Access Compliance Report

Public Rights-of-Way

Intersection ID: 11603	Main Street: AVENTIDE_LN	Cross Street: SERENADE_CT	Location: SE
ADA ID: 133B0E80D5D1	Ramp Type: BlendTrans1	Initial Pass/Fail: Fail	Overall Compliance: No
Severity Score: 1.25			
Codes/Mitigation Info/Possible Solution		Field Measurements/Component Compliance

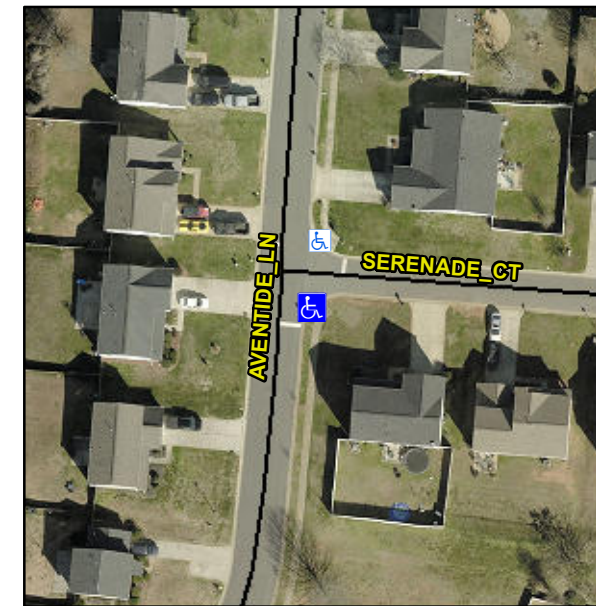
Not Found, R304.5.3

Compliance	Description	Data	Compliance	Description	Data
N/A	Ramp Length (in)	50.0	Yes	BlendTrans Slope (%)	4.2
Yes	Ramp Width (in)	48.0	No	BlendTrans XSlope (%)	3.2
N/A	Flare Type LT	N/A	N/A	Flare Type RT	N/A
N/A	Flare Slope LT (%)	N/A	N/A	Flare Slope RT (%)	N/A
N/A	Flare Traversable LT?	N/A	N/A	Flare Traversable RT?	N/A
N/A	Landing Length (in)	N/A	N/A	DWS Provided?	N/A
N/A	Landing Width (in)	N/A	N/A	DWS Contrast?	N/A
N/A	Landing Slope (%)	N/A	N/A	DWS Length (in)	N/A
N/A	Landing X Slope (%)	N/A	N/A	DWS Full Width?	N/A
N/A	Landing Curb? (Y/N)	N/A	N/A	DWS Offset (in)	N/A
N/A	Shared Landing?	N/A			
N/A	Gutter Ponding?	N/A	N/A	Gutter Slope (%)	N/A
N/A	Gutter Lip Ht (in)	N/A	N/A	Gutter X Slope (%)	N/A
N/A	Painted X Walk1?	No	N/A	Painted X Walk2?	N/A
	X Walk 1 Direction	To N		X Walk 2 Direction	N/A
	X Walk 1 Width (in)	N/A		X Walk 2 Width (in)	N/A
	X Walk 1 Slope (%)	4.6		X Walk 2 Slope (%)	N/A
	X Walk 1 X Slope (%)	2.1		X Walk 2 X Slope (%)	N/A

N/A	Ramp inside XWalk1?	N/A	N/A	Ramp inside XWalk2?	N/A
	Road Slope (%)	2.1		Clear Space?	N/A
	Road X Slope (%)	4.6	N/A	Clear Space to XWalk (in)	N/A
N/A	Any Obstructions?	N/A	N/A	Storm Grate/Utility Hazard?	N/A
	Obstruction Type			Storm Grate/Utility Type	
		N/A			N/A
			Yes	Surface Condition? (G/P)	Good
			No	Curb Slope (%)	16.3

Remove & Replace Curb Ramp With Two New Directional Ramps or Equivalent.
